## Department of Transportation

#### MEMORANDUM

**SUBJECT:** ZC Case No. 25-18 – 2384 Champlain Street NW

Figure 6 | Proposed Curbside Designations

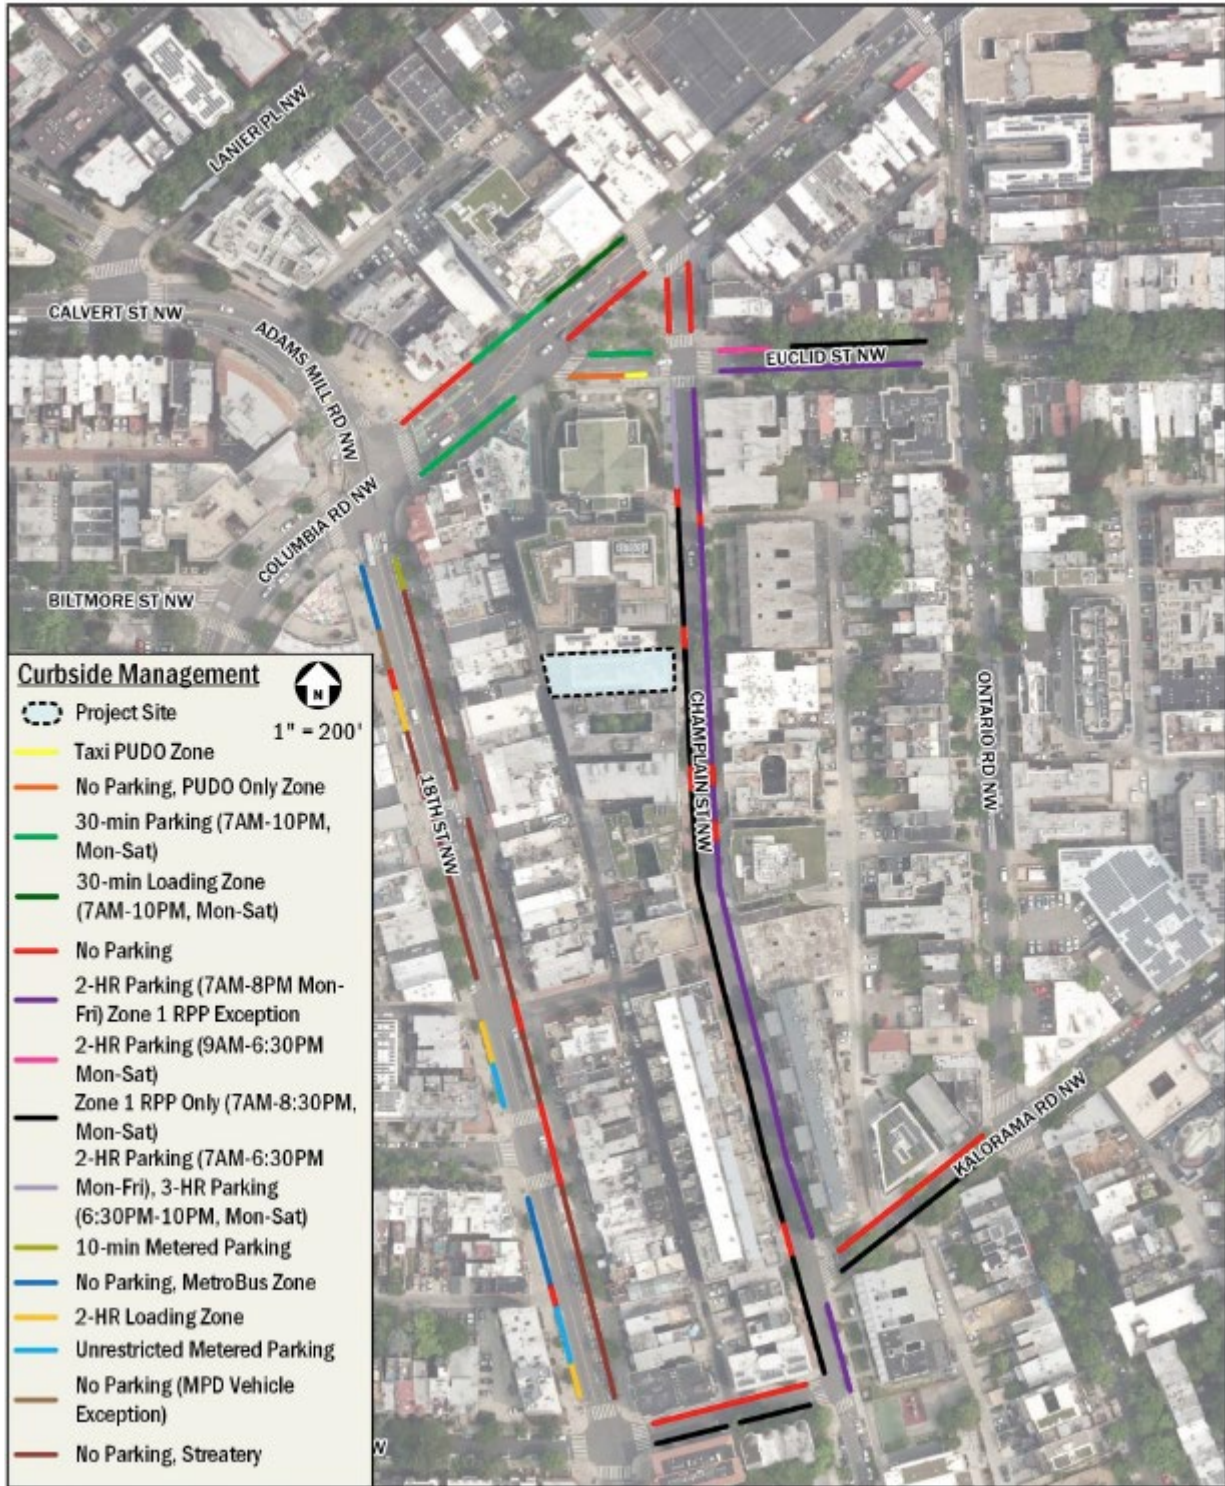
The site currently has Zone 1 Residential Permit Parking Champlain Street frontage, as shown below in Figure 6. The Applicant is not proposing any changes to curbside management. DDOT is generally supportive of this concept, however, a detailed curbside and signage plan must be submitted during public space permitting for review and approval by DDOT’s Curbside Management Division (CMD). At that time, the plan may be refined by CMD and the exact signage placards will be determined. If multi-space meters are required by CMD then they will be at the Applicant’s expense.
